Office Action Summary

09/973,133

YAMAZAKI ET AL.

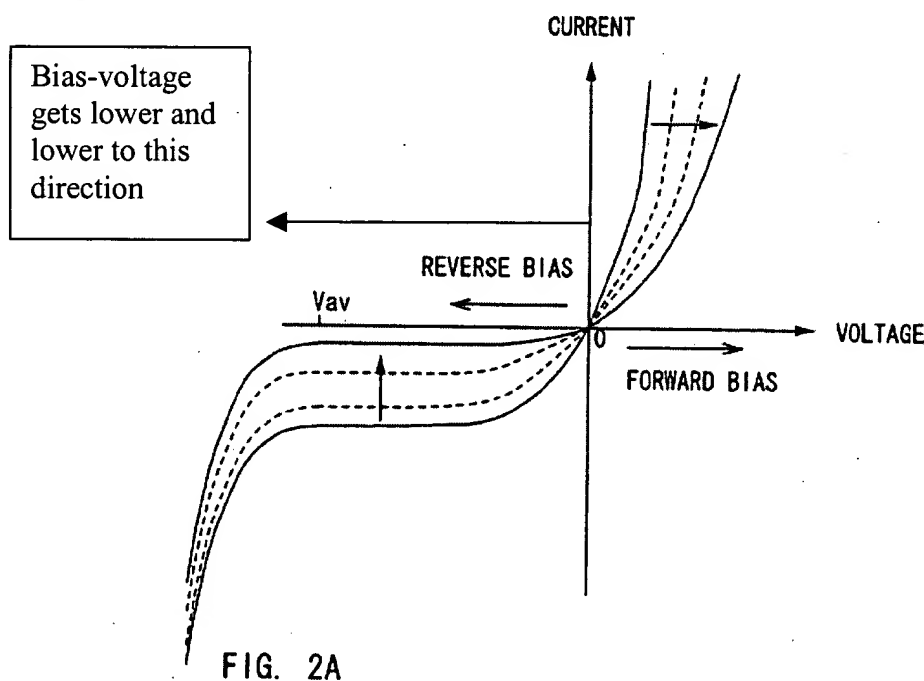
Claim 9 recites the limitation "wherein magnitude of the second reverse bias voltage is higher than magnitude of the first reverse bias voltage" in lines 8-9. However, the recited limitation is not clear in its meaning and scope for the following reasons:

As shown in Fig. 2A of the instant application and depicted herein below, the reverse bias is a negative bias voltage.

However, it is not clearly specified in the claim that which magnitude of the first and the second reverse bias voltages are claimed. As shown in Fig. 2A the reverse bias voltage gets further lower and lower when further out the left of the abscissa. However, it is not clear at what point the first and the second bias voltages are taken. Hence, the claim lacks clarity in its meaning and scope. Therefore, the claim is indefinite for failing to particularly point out and distinctly claim the subject matter which applicant regards as the invention.
